California Department of Transportation

Rancho Guejito Wine Tasting Facility and Event Center
MND/ SCH# 2022120692

Caltrans has the following comments:

MAURICE EATON

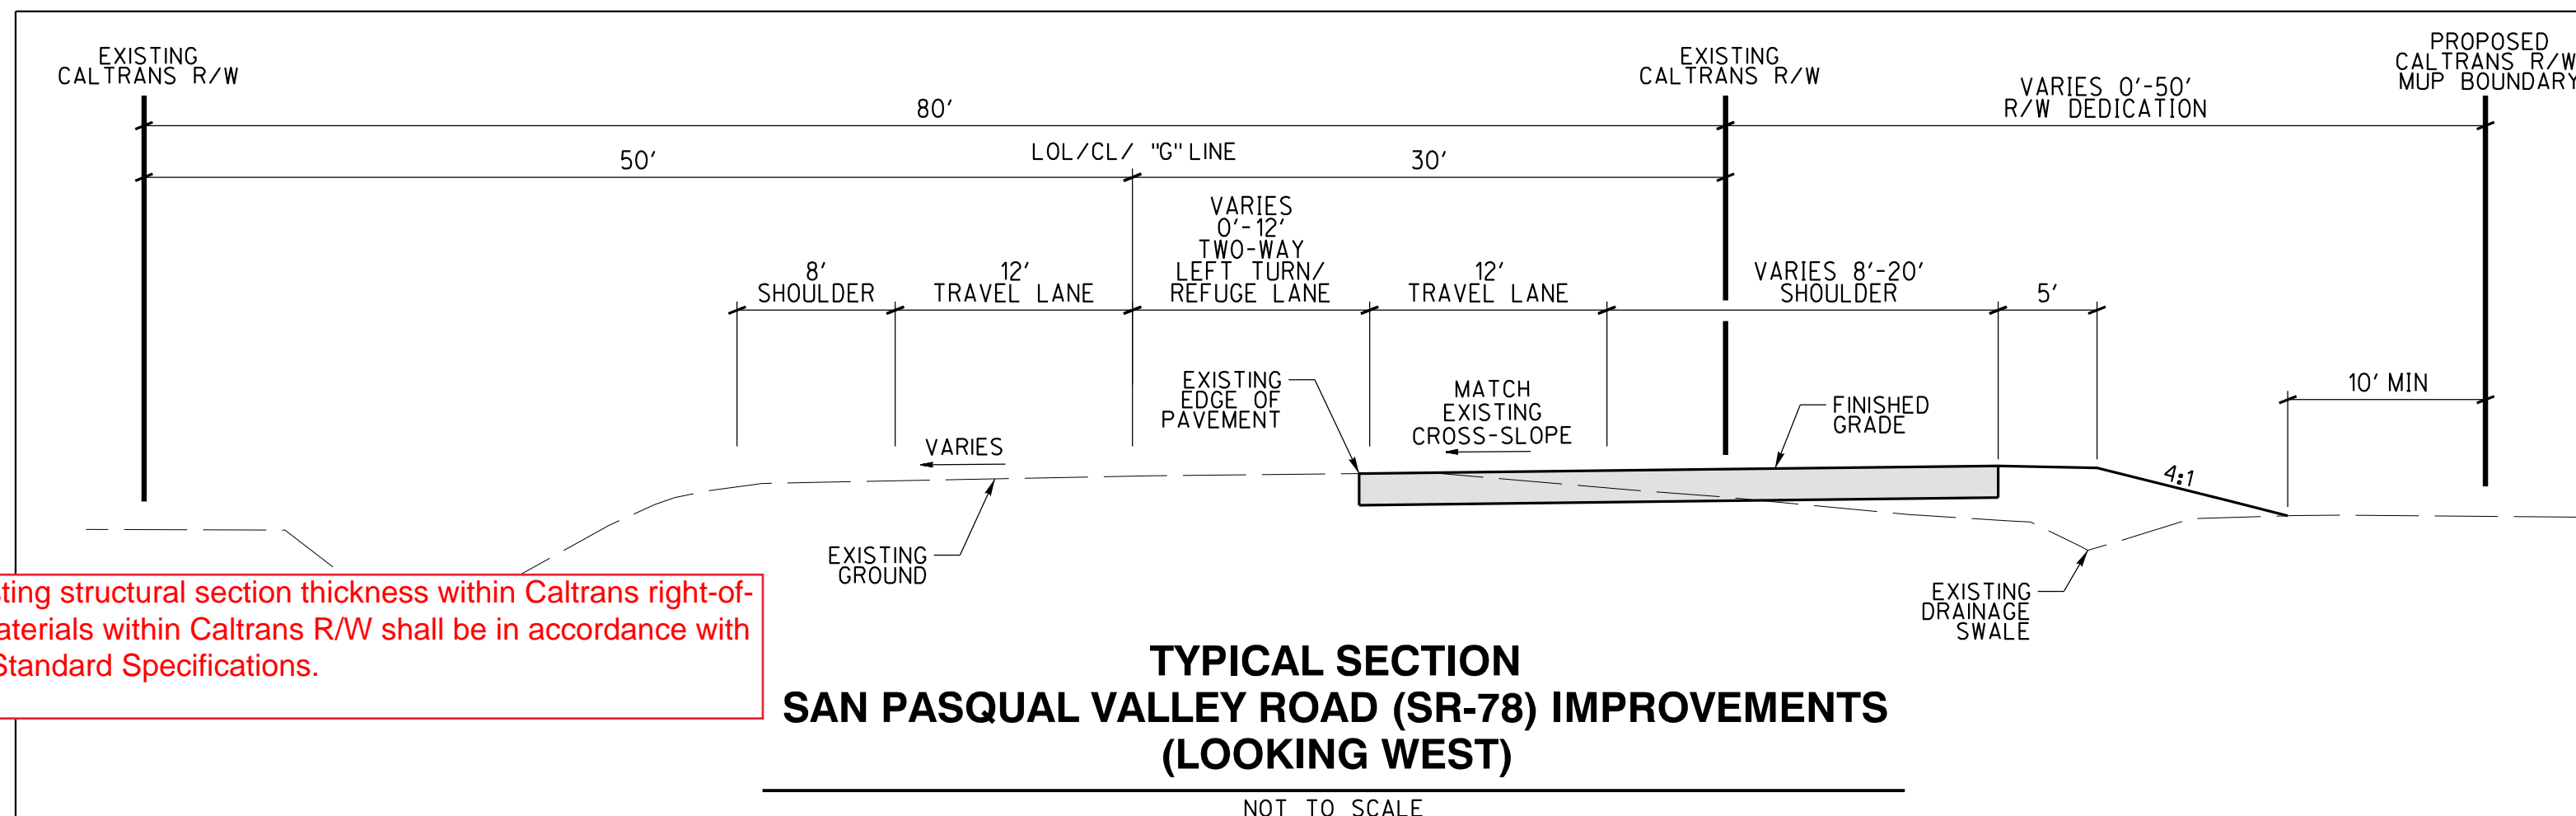
- The location of the driveway shall be designed to maximize corner sight distance. For corner sight distance, see the Caltrans Highway Design Manual (HDM) Index 405.1(2)(c). Driveway proposals that do not meet sight distance requirements will not be permitted. The minimum corner sight distance shall be equal to the stopping sight distance as given in HDM Table 201.1. HDM Table 101.2 shows appropriate ranges of design speeds that shall be used for the various types of facilities, place types, and conditions listed. (See HDM Table 101.2 Vehicular Design Speed; Table 201.1 Sight Distance Standards; Index 205.4 Driveways on Frontage roads and in Rural Areas; Index 405.1 (2) Corner Sight Distance).

- Driveways connecting to State highways shall be paved a minimum of 20 feet from the edge of shoulder or to the edge of State Right-of-Way (R/W), whichever is less to minimize or eliminate gravel from being scattered on the highway and to provide a paved surface for vehicles and bicycles to accelerate and merge. Where larger design vehicles are using the driveway (e.g., dump trucks, flatbed trucks, moving vans, etc.), extend paving so the drive wheels will be on a paved surface when accelerating onto the roadway (See HDM Index 205.4 Driveways on Frontage roads and in Rural Areas).

- Approach and departure tapers should be 50 feet longitudinal and 8 feet from edge of traveled way at the end of the taper. Approach and departure tapers are not required where the existing paved shoulder is at least 8 feet wide (See HDM Figure 205.1 Access Openings on Expressways).

- Approach and departure tapers should have structural sections matching the existing State highway shoulders. An alternate shoulder design is allowed. See Caltrans HDM Figure 613.4B for details. For asphalt driveway the structural section should be equal to or greater than edge of shoulder or approach and departure tapers. Minimum thickness of surface course is 0.35 foot. Aggregate base depth should match State highway shoulders. Details (cross section, etc.) for concrete driveways are shown on Standard Plan A87A. Minimum thickness at driveway shall be 4 inches for residential and 6 inches for J-1 commercial. (See HDM 613.4(2) Shoulders; Standard Plan A87A Curb and Driveways).

- Place shoulder backing from the edge of pavement (EP) to the hinge point (HP). Shoulder backing should be placed on a width of at least 2 feet from EP. For placement of shoulder backing thickness greater than 0.5 foot for slope repair; shoulder backing behind dikes; and where longitudinal drainage are present; see HDM for details. (See HDM Index 672 Shoulder Backing and HDM Figures 672.3 A through E).
- Where County Regulations differ from the State's, it may be desirable to follow County regulations (See HDM Index 205.4 Driveways on Frontage roads and in Rural Areas).

*Corner Sight Distance shall be calculated from all directions of approach. See HDM Index 405.1(2) & Figure 405.7 for set back and sight distance calculations.

Attachment - Materials Engineering_Redline Cmmnts_Rancho Guejito

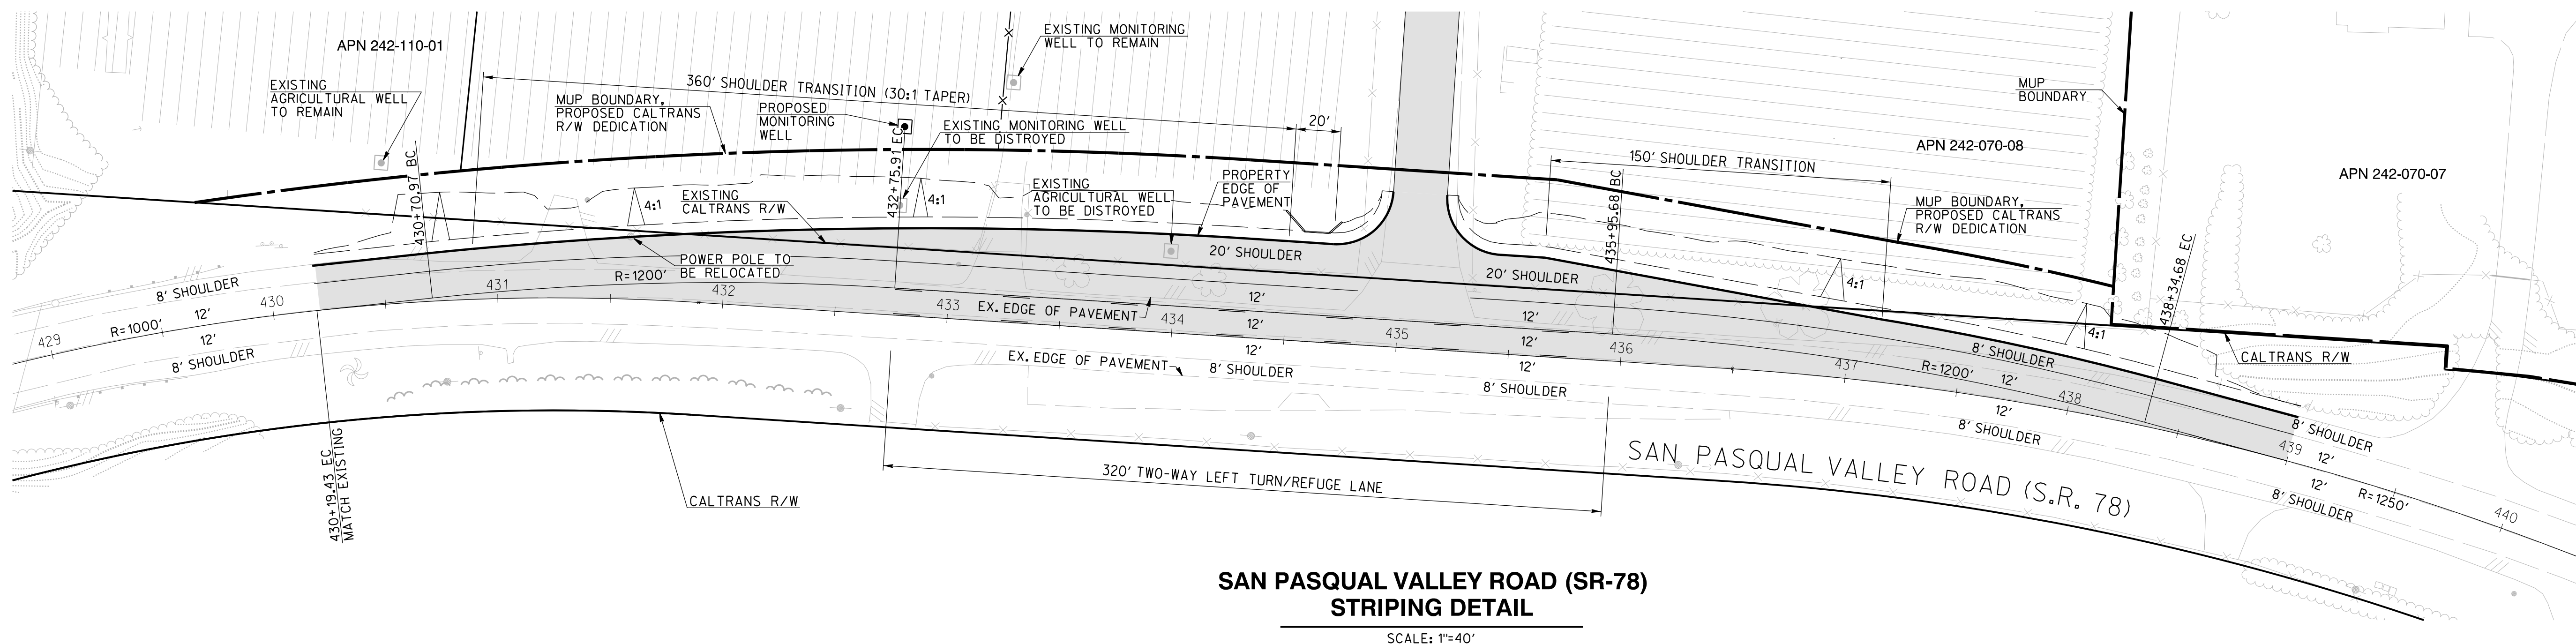
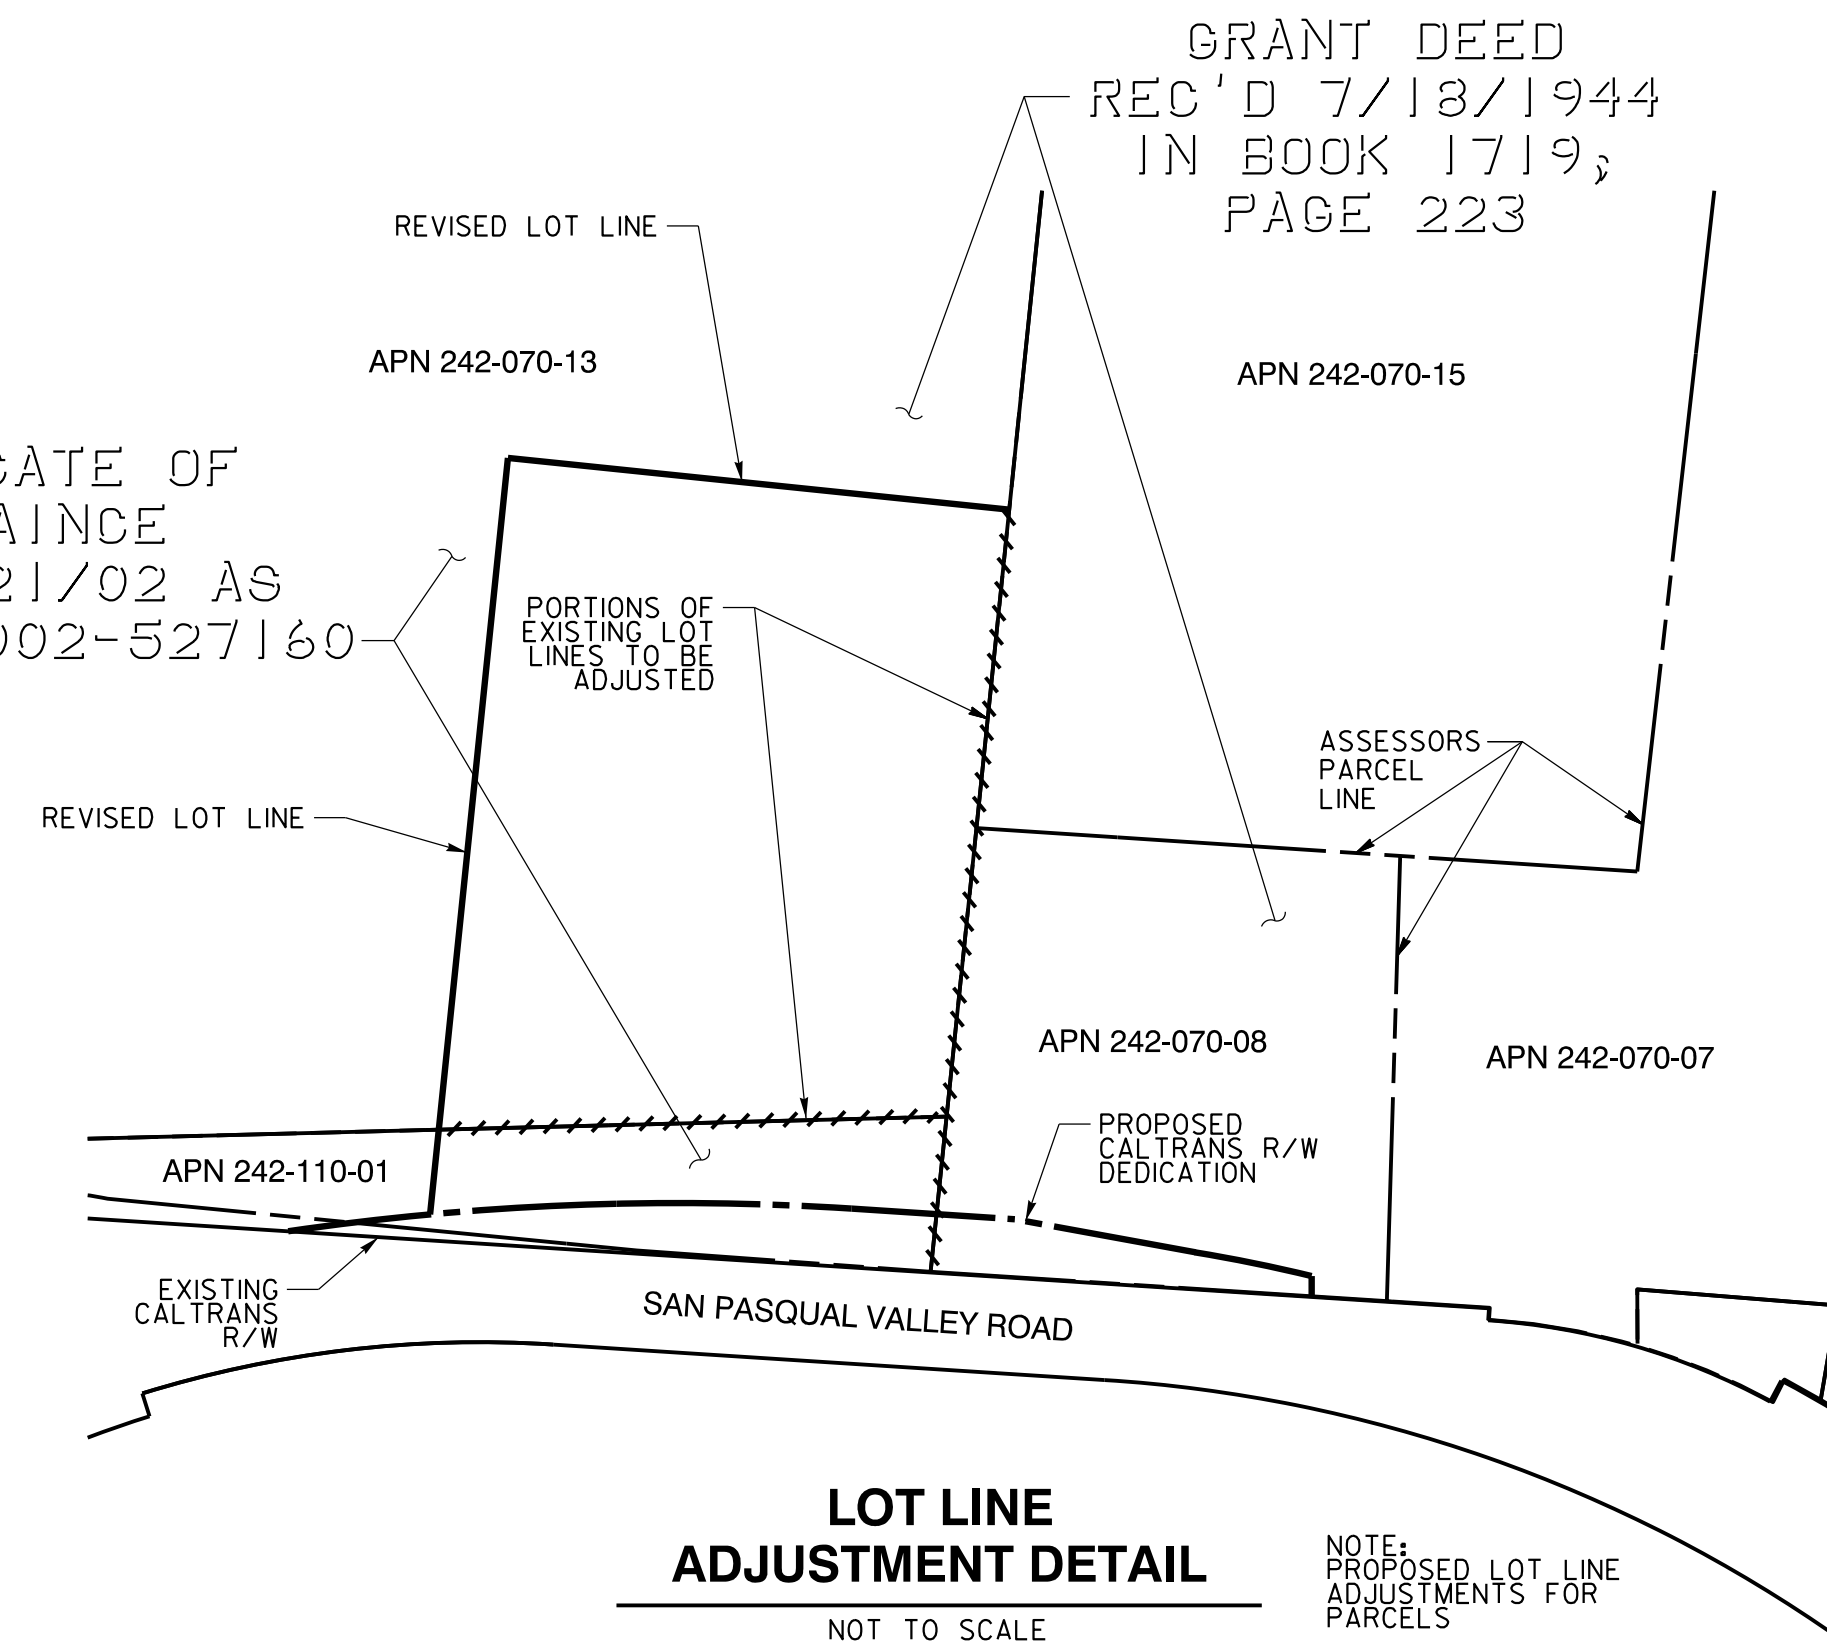
Match existing structural section thickness within Caltrans right-of-way. All materials within Caltrans R/W shall be in accordance with the latest Standard Specifications.
